Town of Hilton Head Island Regular Design Review Board Meeting

March 22, 2016

DESIGN TEAM/DRB COMMENT SHEET

SITE PLAN
SCALE 1"=30'

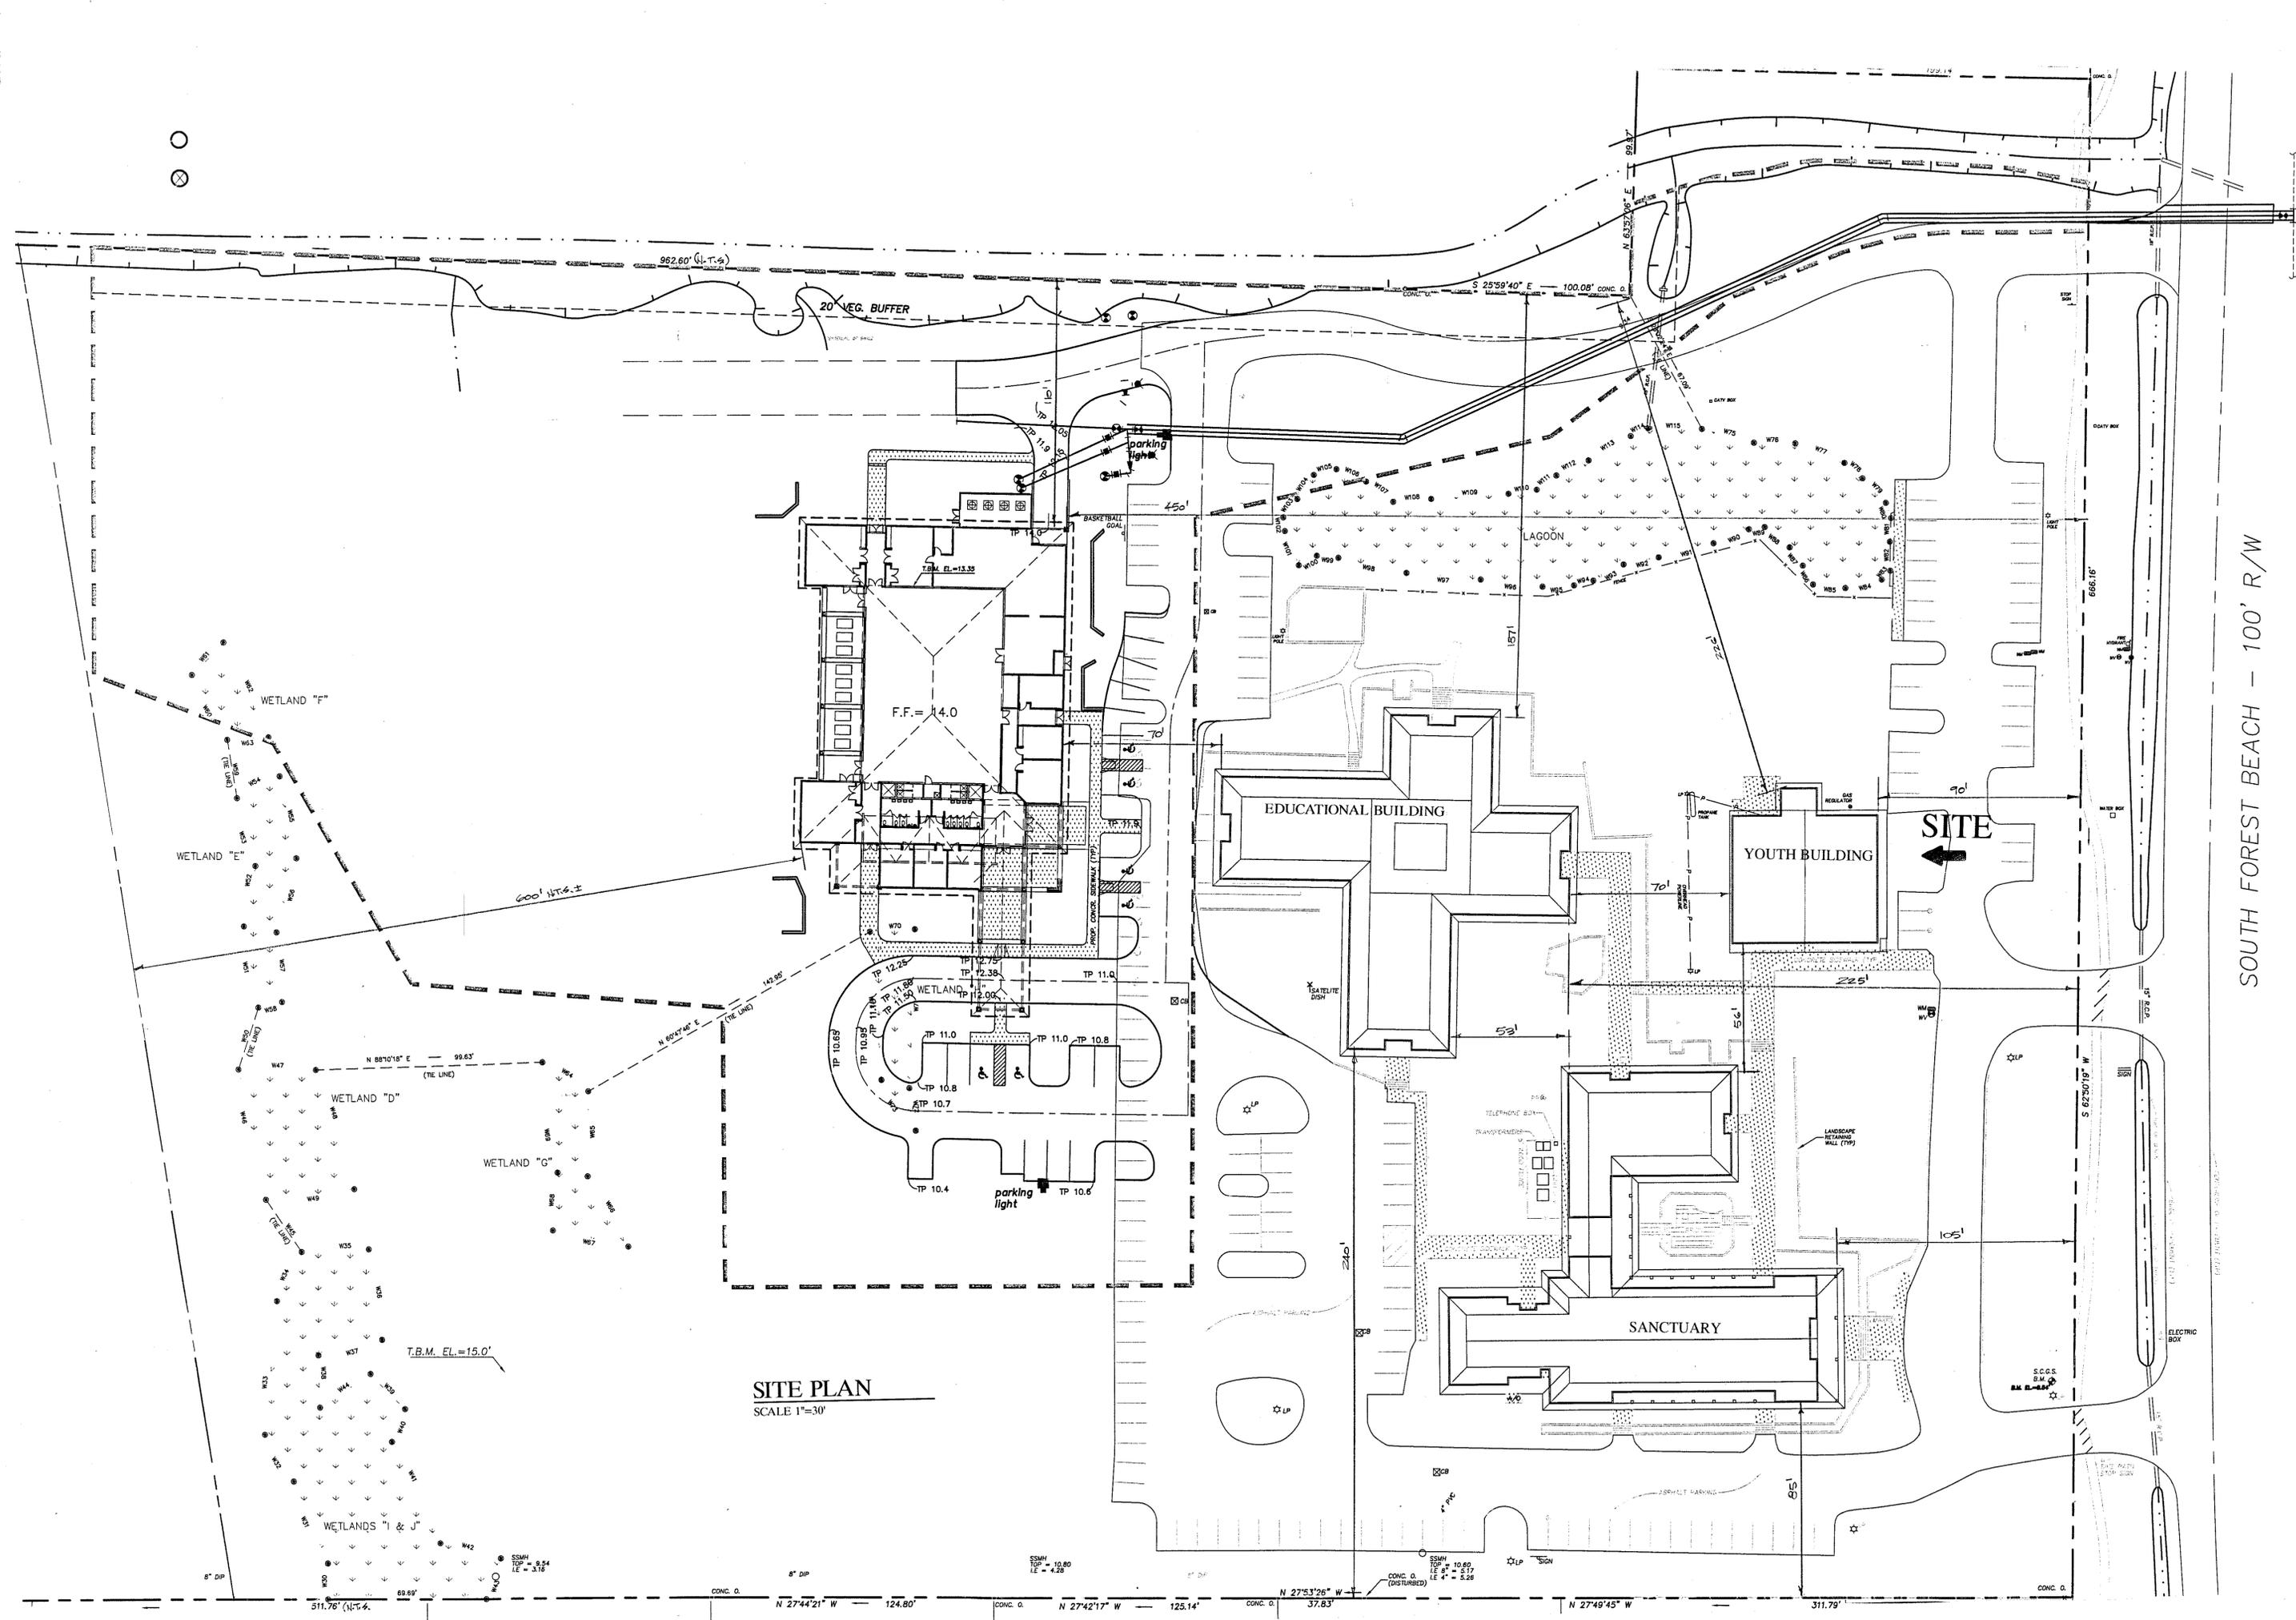
The applicant proposes to replace the existing flat & 6/12 roof with a 3/12 roof with asphalt shingles in 'Weathered Wood'. Existing sliding glass doors are proposed to be replaced with windows and shiplap siding to match existing below the windows. The existing double entry door as well as a new single door are proposed to be etched glass similar to existing doors on other church buildings.

MINOR ALTERATION
 NEW YORK CITY PIZZA RESTAURANT
 81 POPE AVE.
 HILTON HEAD ISLAND, S.C.

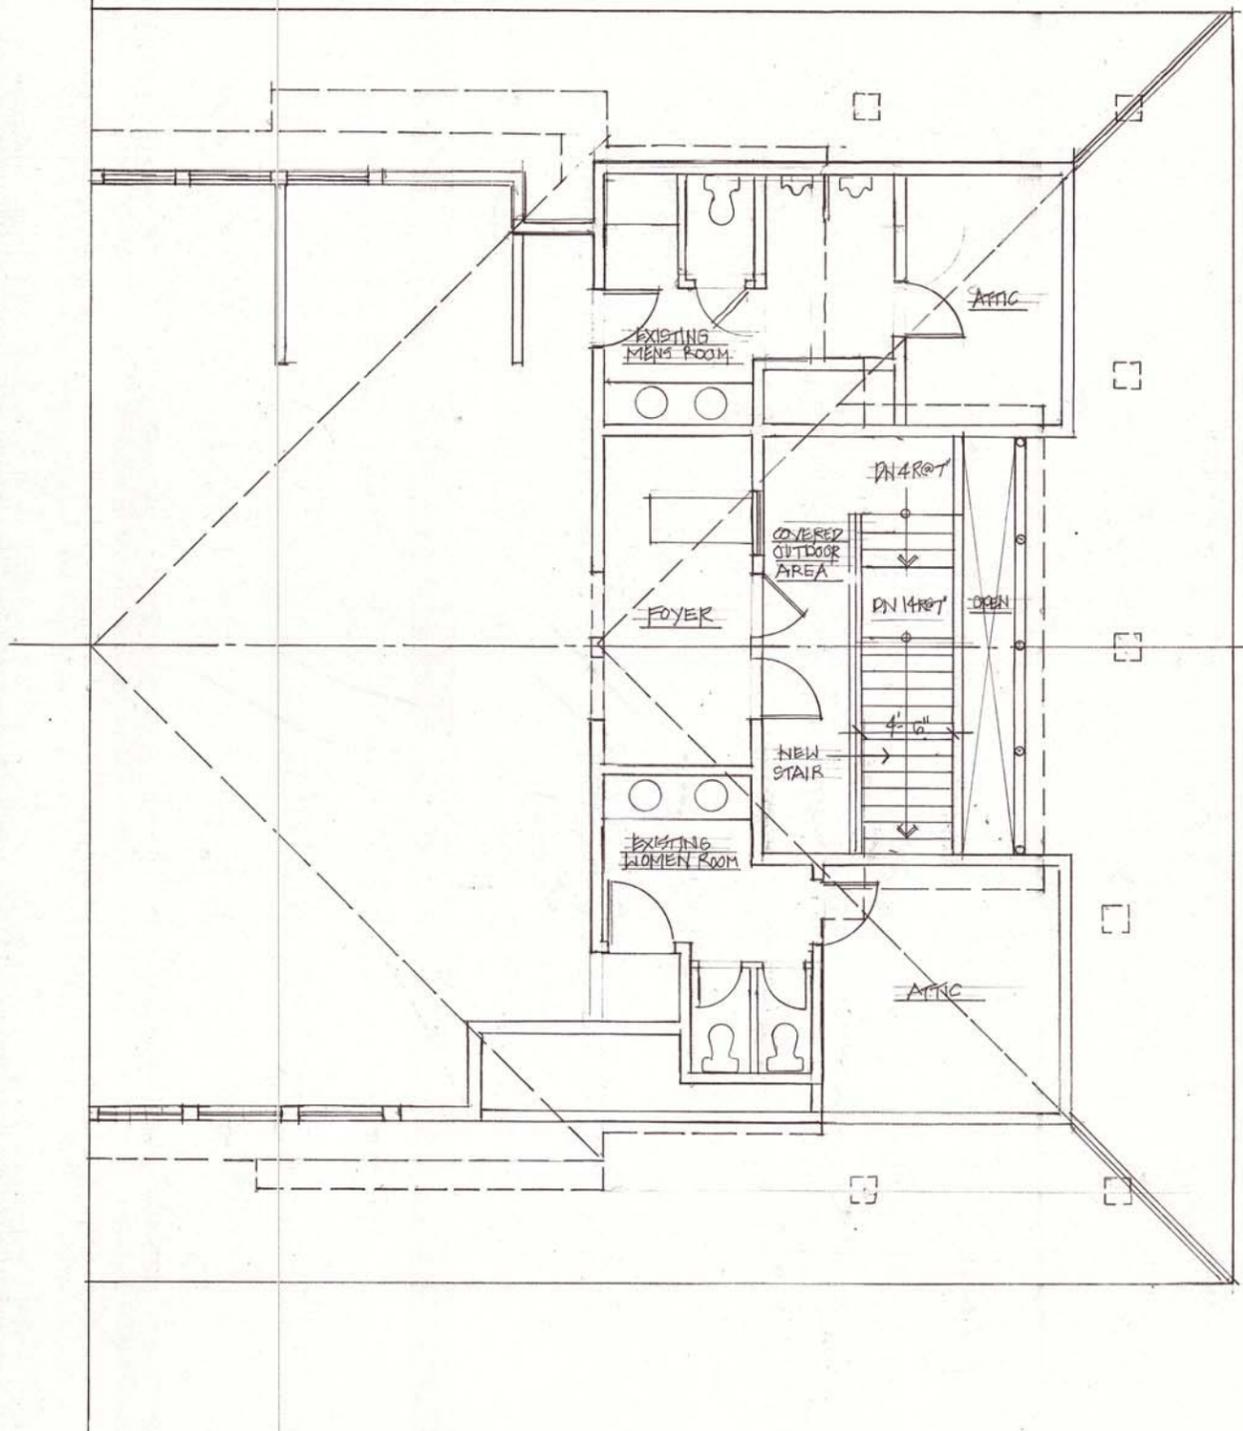
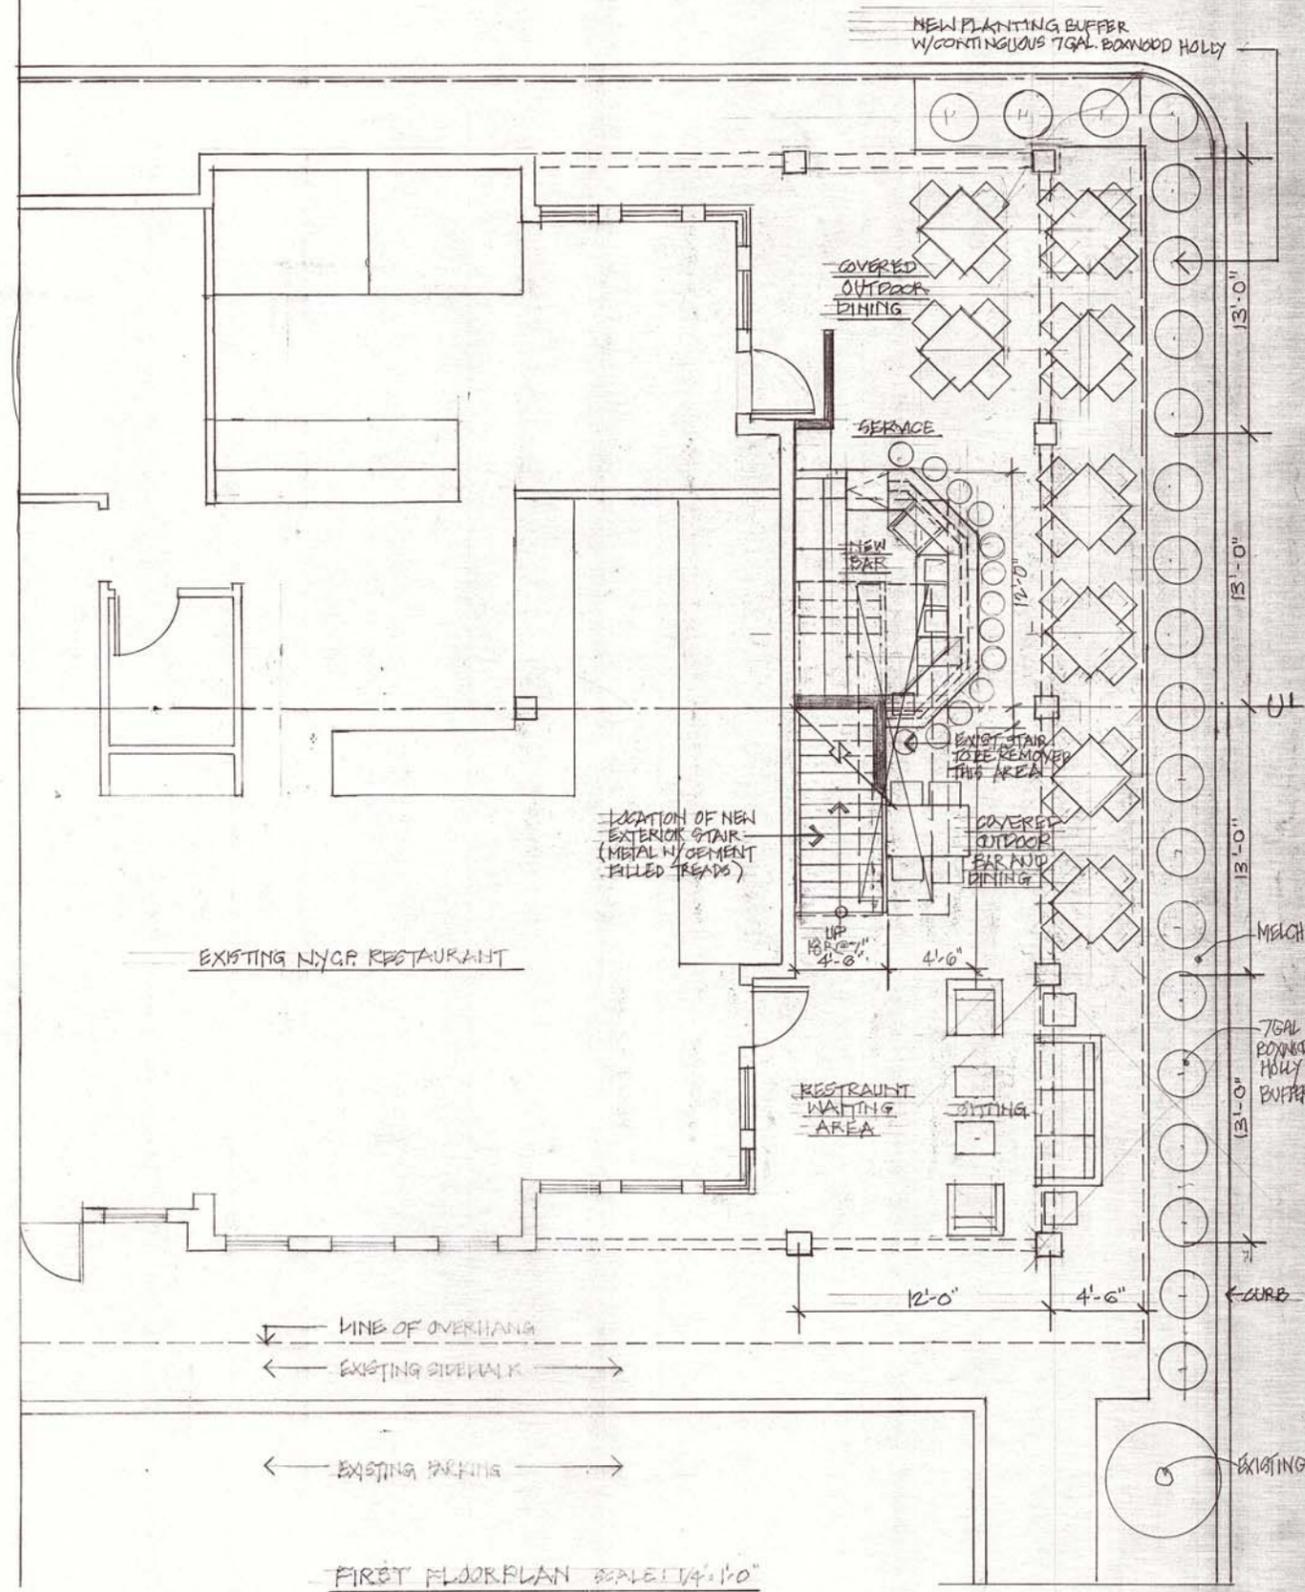
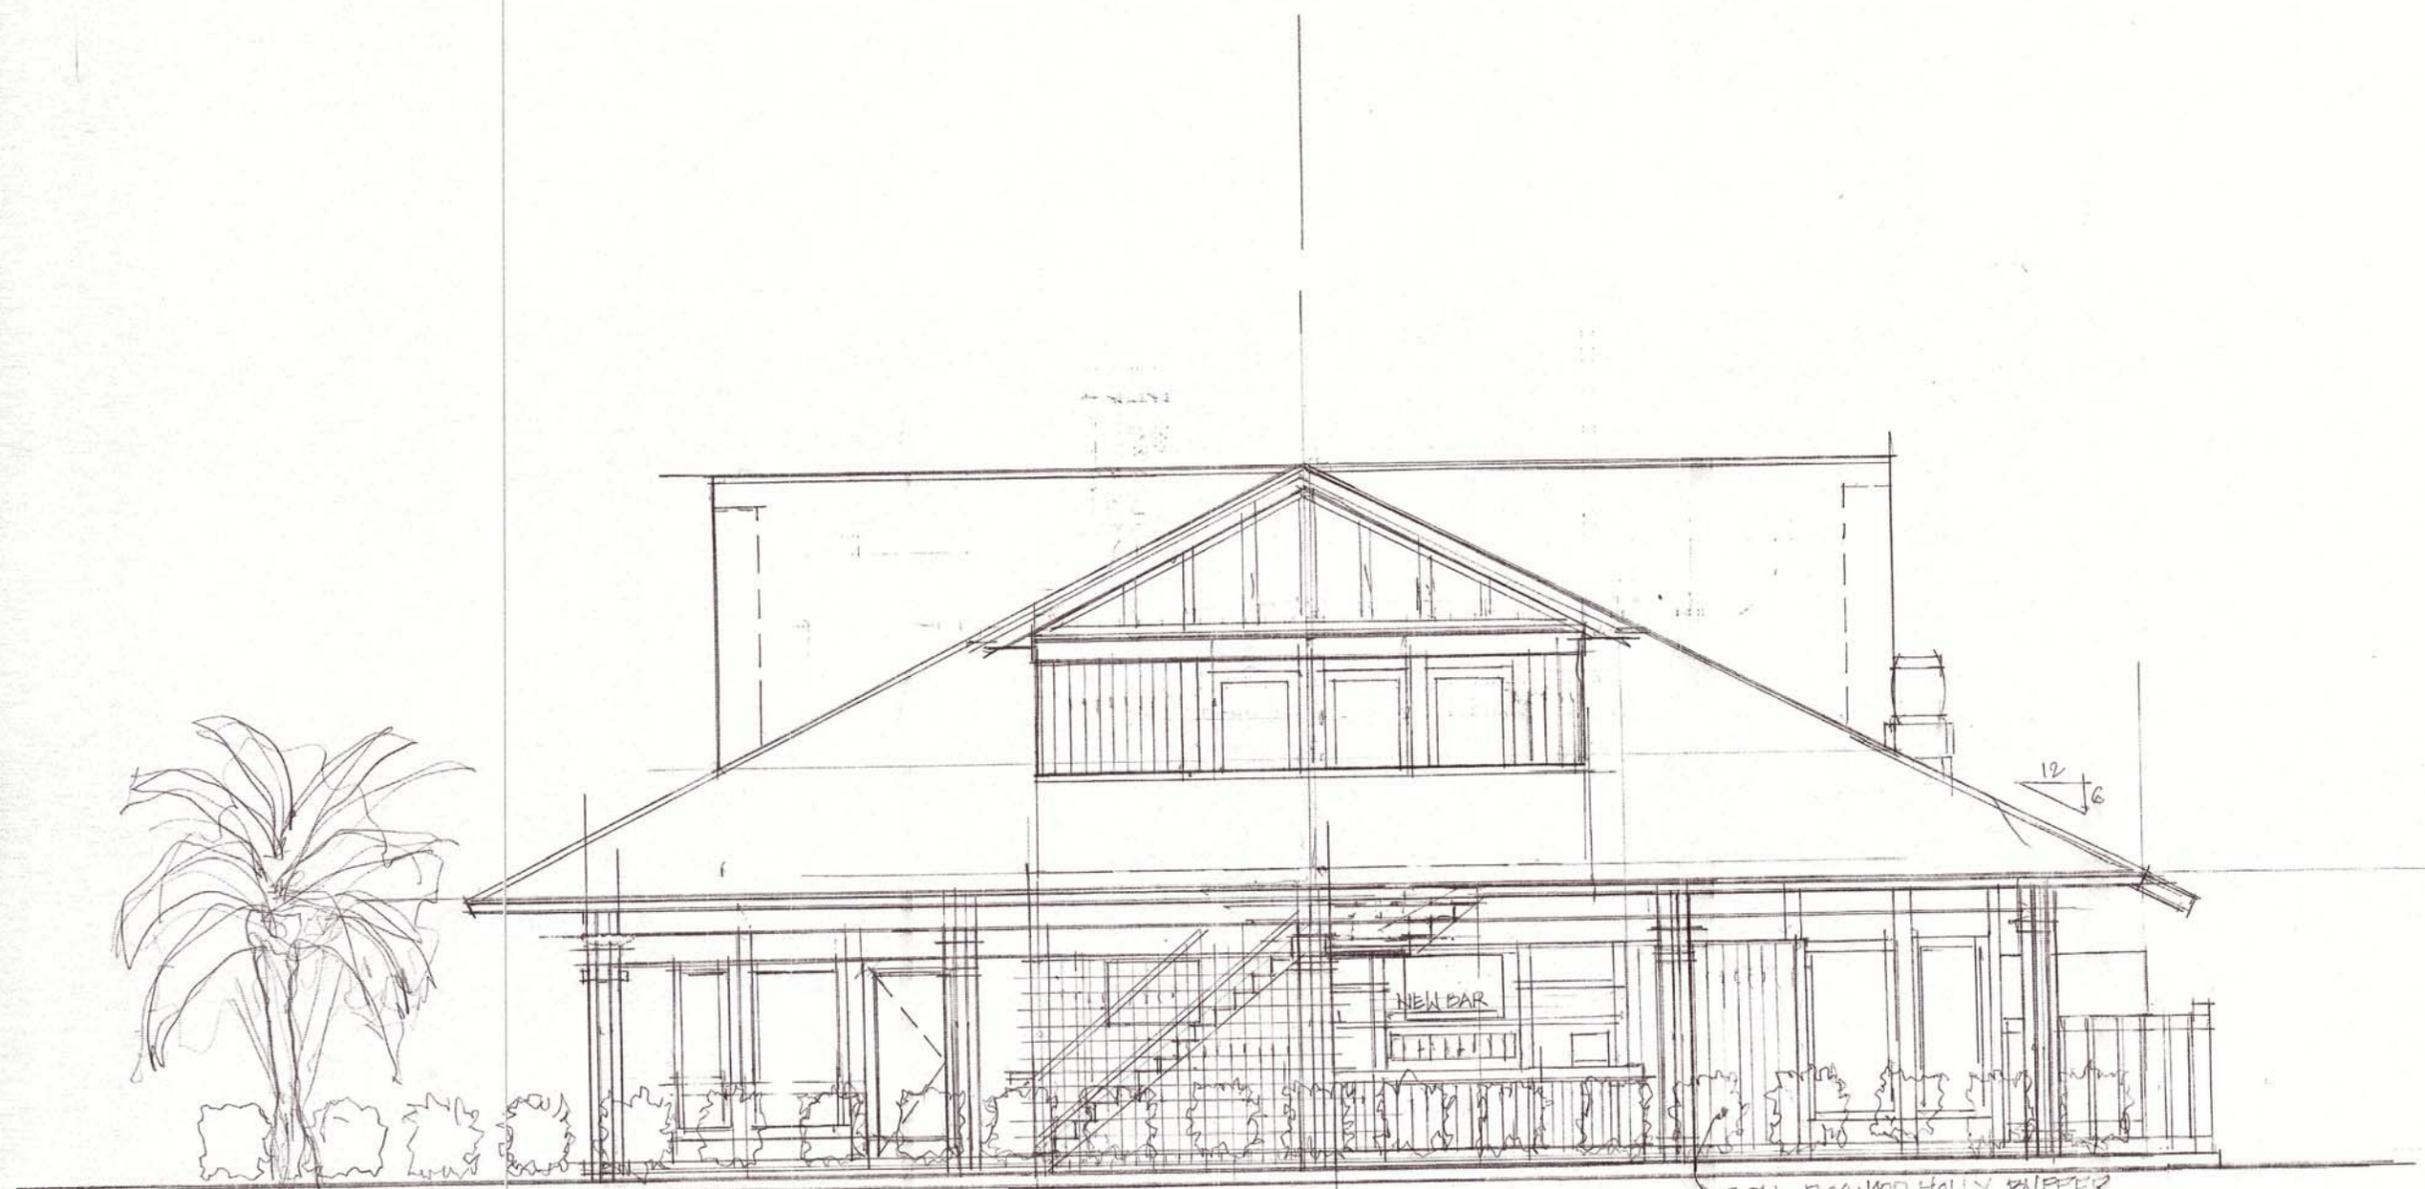
1. Specify plants for buffer between parking lot and patio.
2. Specify all colors and materials, including finish of distressed vertical wood siding and bar.
3. Coordinate with Heritage Plaza owners regarding proposed redevelopment and addition of walkway from Pope Avenue to proposed hotel adjacent to NYC Pizza.
